FACPAC Contract Change Order Supplemental Information Form (Ref# 56328)

Tier 1 Project: ECHS Renovation Phase #7

Change Order - Construction Manager-Adviser Edition

CHANGE ORDER NUMBER: 12-2
INITIATION DATE: 5/3/2022

P4.1B

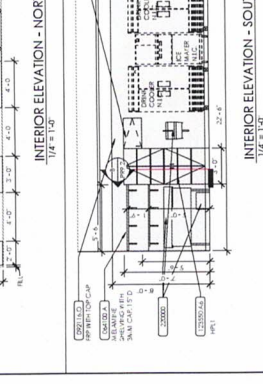
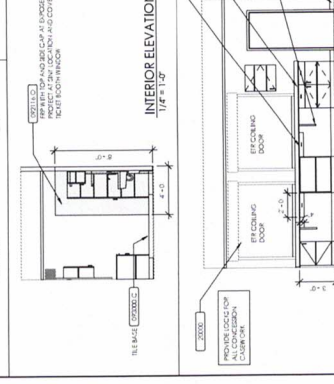
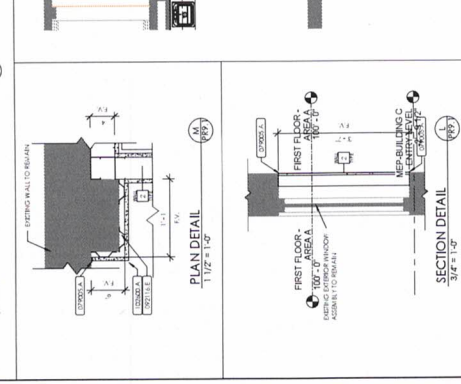
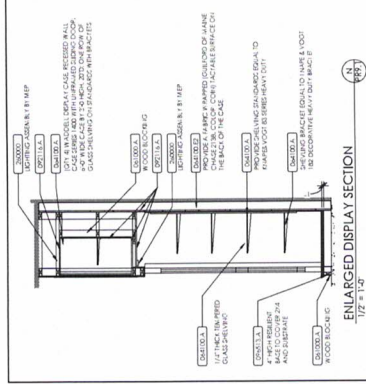
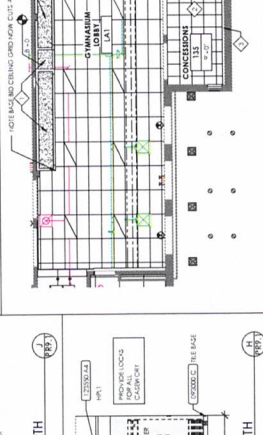
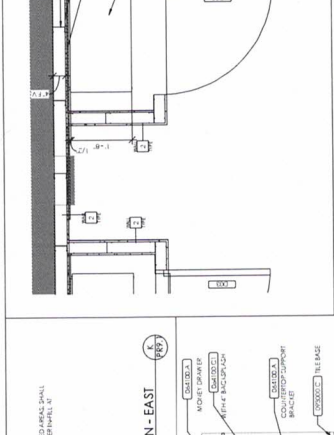
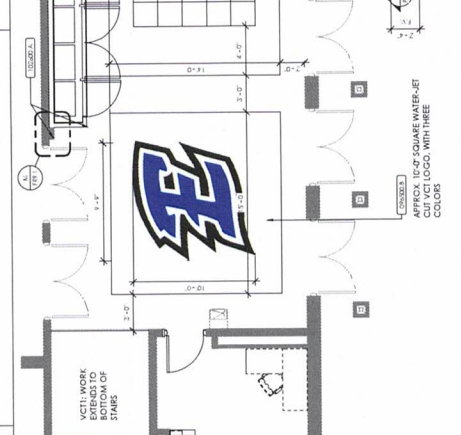
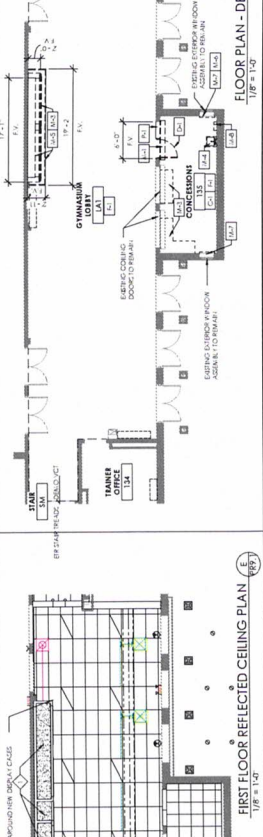
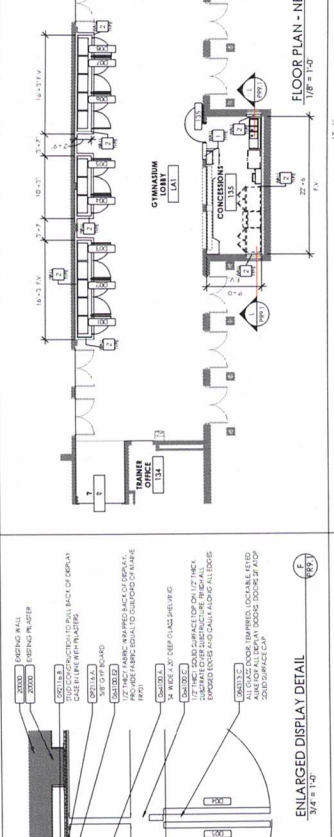
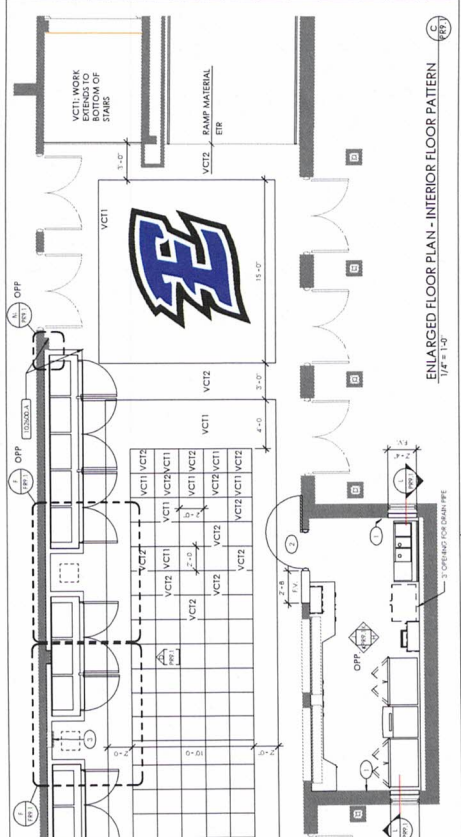
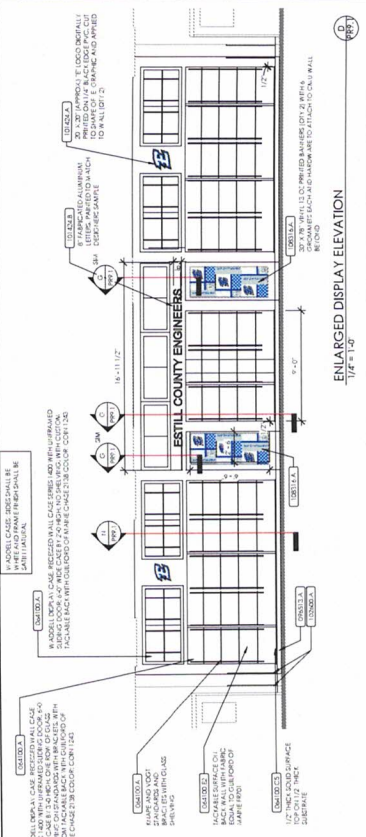
REMARKS: Refer to attached sheet P4.1B. Provide three compartment sink and grease interceptor with plumbing connections. Provide new hand sink with plumbing connection. Field verify exact locations to connect to the existing sanitary, vent and domestic water lines.

P3 VERIFY EXIST'G LOCATION. REMOVE CEILING AND
NEEDED TO INSTALL VENT AND DOMESTIC WATER
LINES. REPAIR WALLS TO MATCH EXISTING.
P5 REMOVE EXISTING WATER PIPING. FIELD VERIFY EXACT
LOCATION. REWORK LINES TO CONNECT TO NEW
FEATURES.
P6 CONNECT TO EXISTING 3" SANITARY LINE. FIELD
VERIFY EXACT LOCATION AND DEPTH. FLOOR SLAB
SHALL BE SAW CUT AND REPAIRED TO MATCH
EXISTING.
P7 CONNECT TO EXISTING VENT PIPING. FIELD VERIFY
EXACT LOCATION.
P23 CONNECT TO EXISTING DOMESTIC WATER AND VENT
PIPING IN THIS AREA. FIELD VERIFY EXACT LOCATION
AND DEPTH. REPAIR WALLS TO MATCH EXISTING.
WATER LINES SERVING PLUMBING FEATURES.
P47 REMOVE EXISTING CHASE WALLS AND SAW CUT
FLOOR SLAB AS NEEDED TO CONNECT TO EXISTING
PIPING. FIELD VERIFY EXACT LOCATION AND DEPTH.
REPAIR WALLS TO MATCH EXISTING.

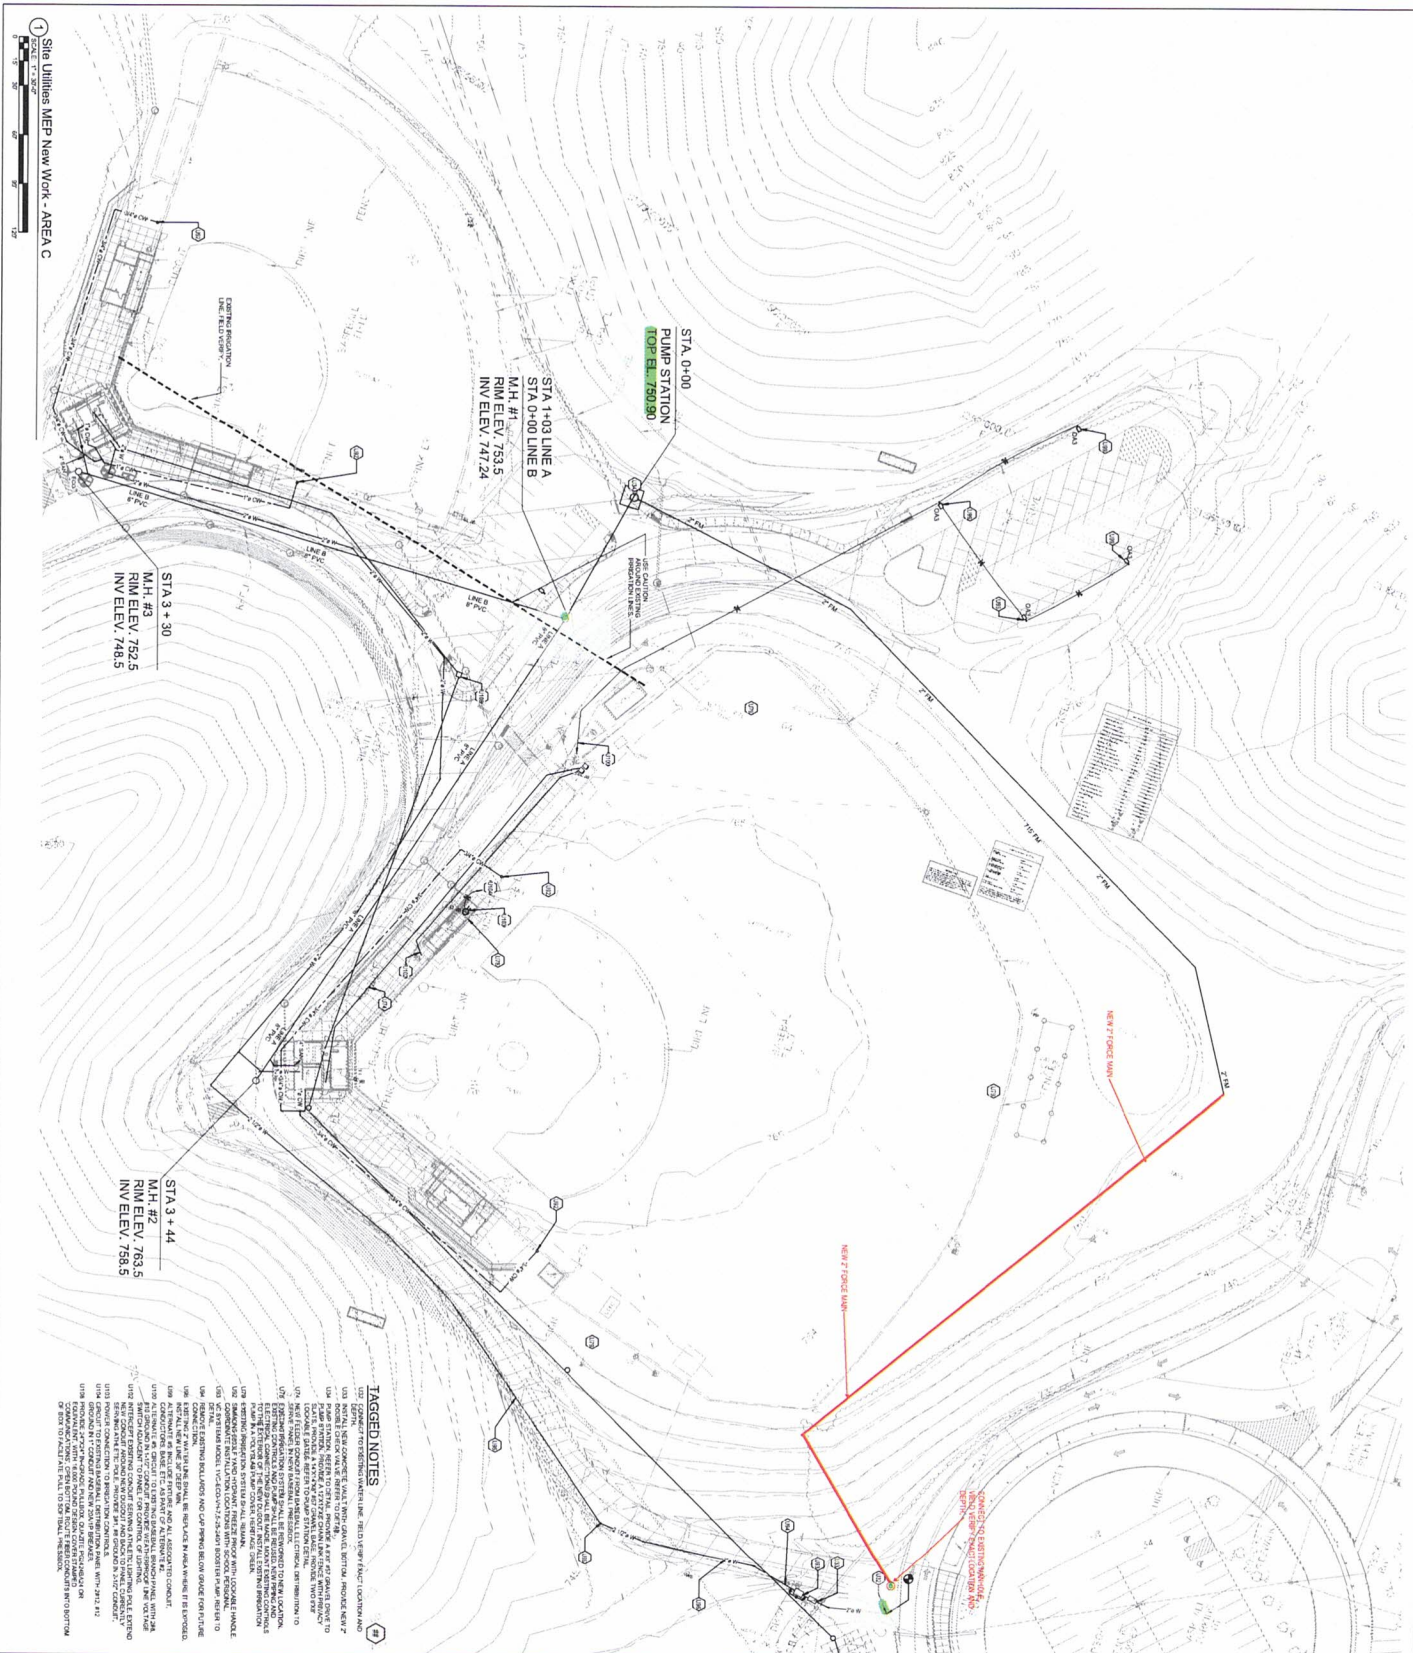
7. Provide pricing per foot for the excavation and pipe for extending the 2" force main sewer from behind center field fence down along the right field fence and tie into the manhole found in the Baseball Softball Complex entrance. See attached drawing.

LOWER LEVEL PLUMBING PLAN

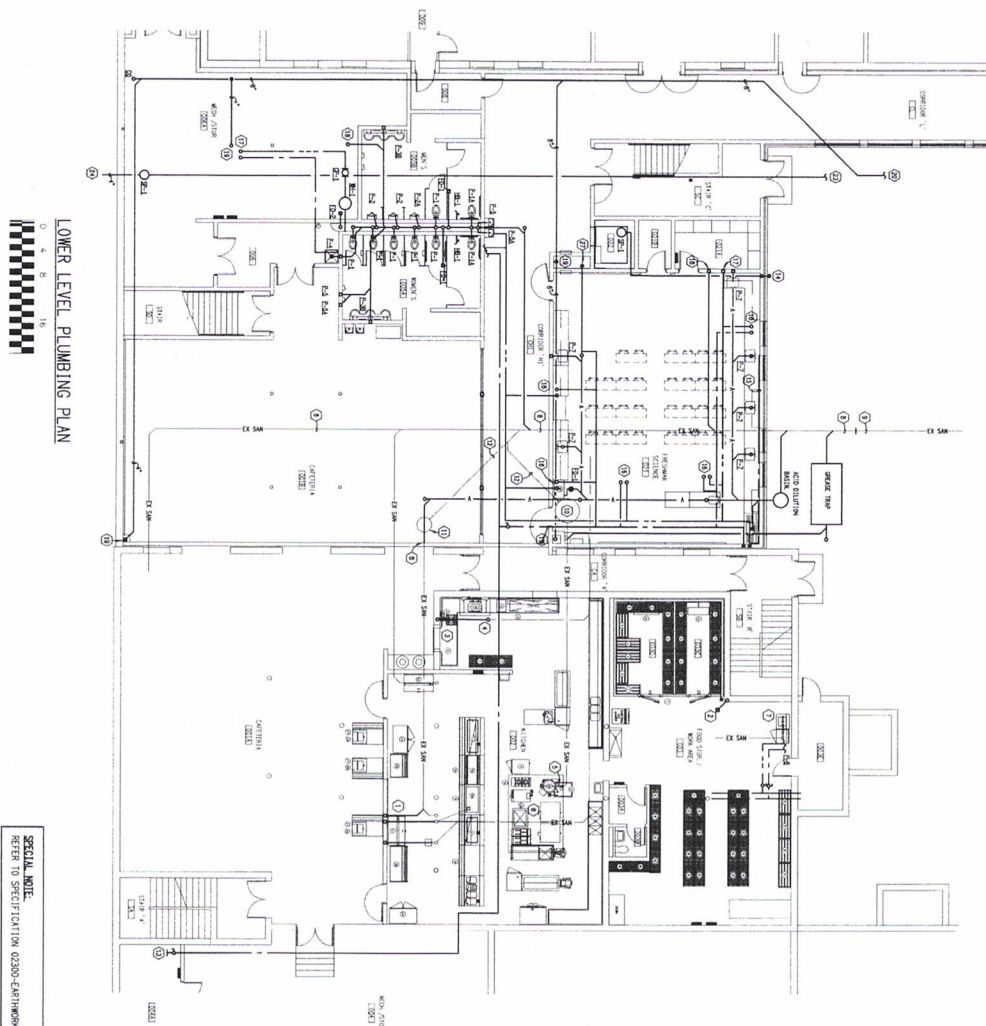
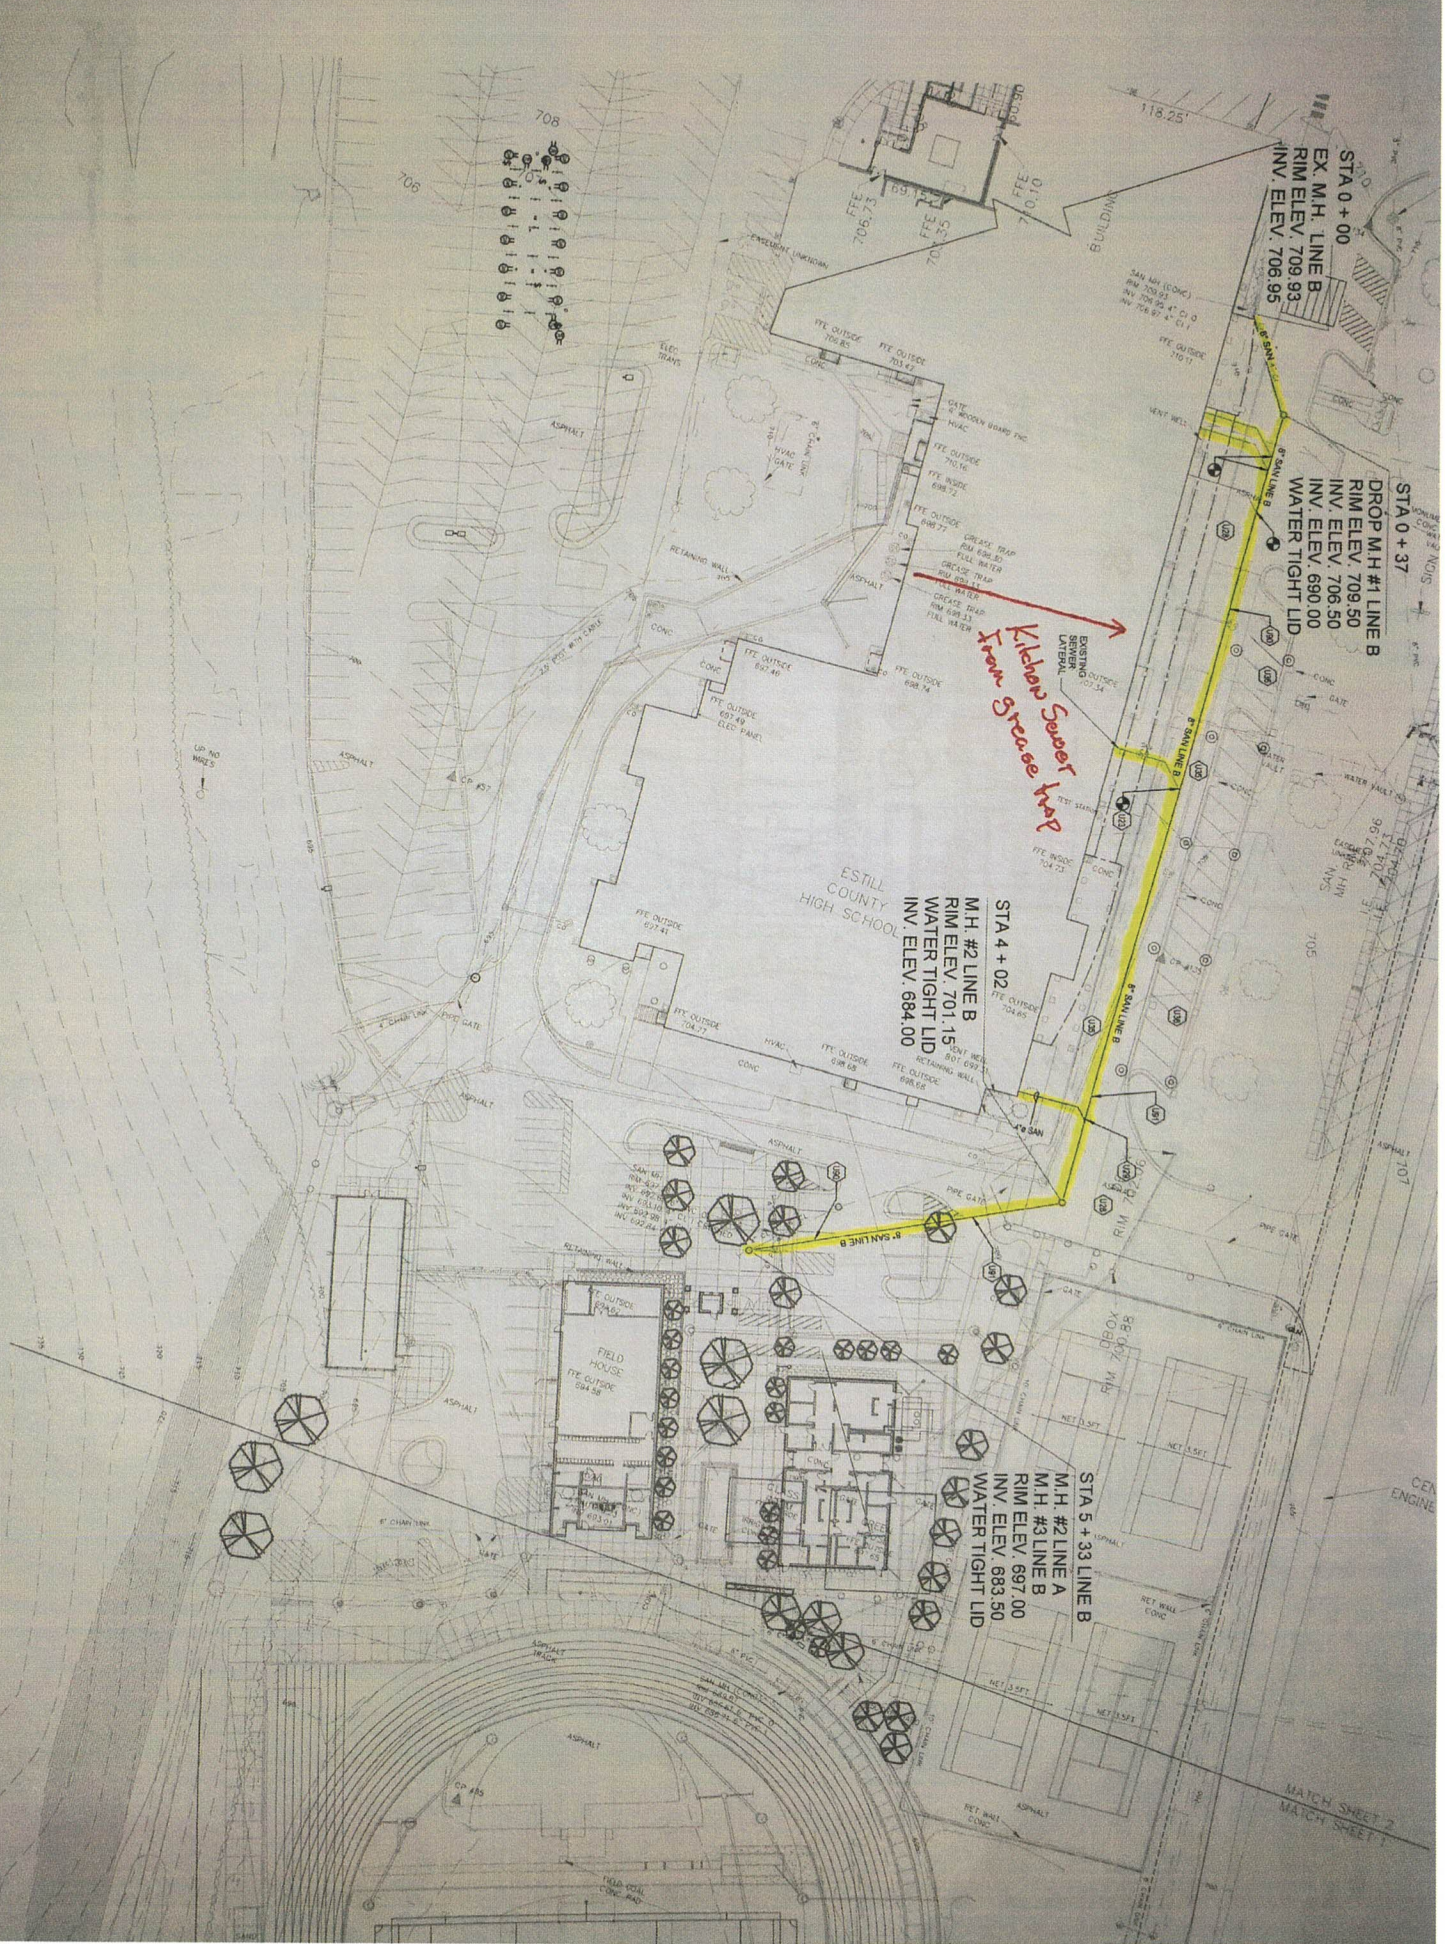
The amendment to the recently submitted PR-012 Manhole Exploration. The Owner is requesting the Contractor provide pricing to camera the existing exterior sewer from manhole to manhole highlighted on the attached plan Sheet U4.1 and the interior Kitchen sewer from grease trap to the exterior sewer, see attached High School plumbing plan sheet P-1.

Picture of Manhole #1 serving the Estill County Middle School

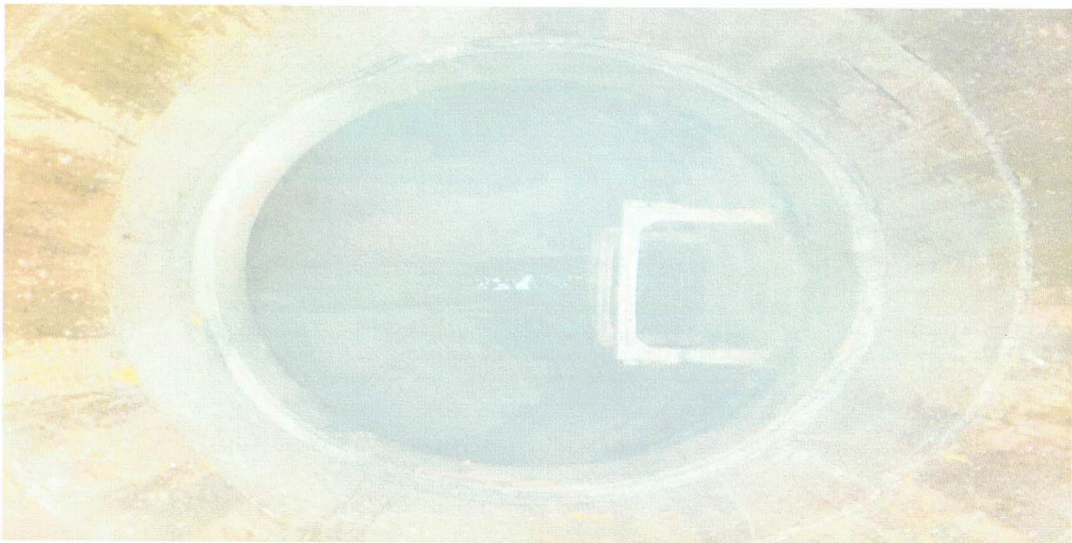
Picture of unknown Manhole #2, the questionable unknown pipe is from manhole to the sign seen in the distance, line representing the expectant routing of 4" PVC sewer pipe.

The picture of manhole with lid remove shows the direction of flow may continue to Manhole #1 and continue to the Baseball Softball entrance drive way.

The Contractor has found an unknown 4" PVC pipe in the drive way of the Baseball Softball drive way, approximately in the center of entrance.

The Contractors shall open Manhole #2 and clean and remove all gravel and clay from the pipe routing back to Manhole #1, the distance taken with a laser is +/- 195' from manhole to manhole. The pipe once cleared of blockage shall be camera and the video recording of the pipe interiors shall be submitted to the Architect. Do not allow any blockage materials to flow through and or pass the Manhole #1 invert.

Estill County A T C project drawing UM1.0, Unknown Manhole #2 and Manhole #1.

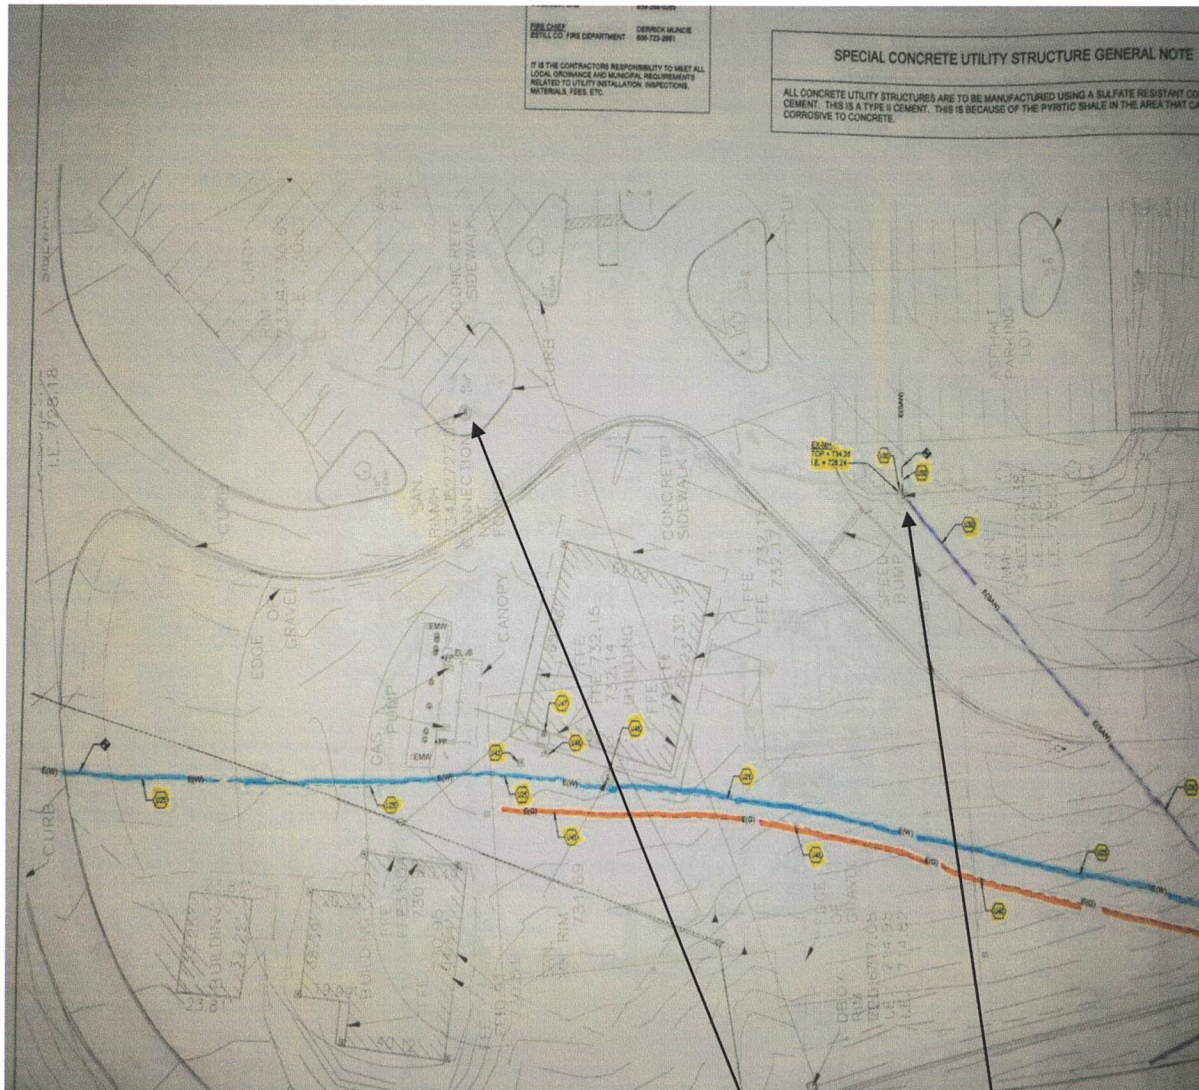
The Contractor shall clean and remove all blockage in the 4" sewer pipe leading towards the Baseball Softball Field drive way. The goal is to locate and confirm this pipe does terminate and end in the center of the driveway. Note; it is possible there is an unknown manhole located somewhere in this driveway or adjacent culvert. This unknown pipe if it does come from Manhole #2 shall be camera and the video recording submitted to the Architect, the laser distance take is +/- 285' from manhole #2 to the sign seen in the above picture.

The Contractor shall provide a unit pricing for extending the installed force sewer main from the present location north of Baseball Field fence to the 4" sewer in the entrance driveway.
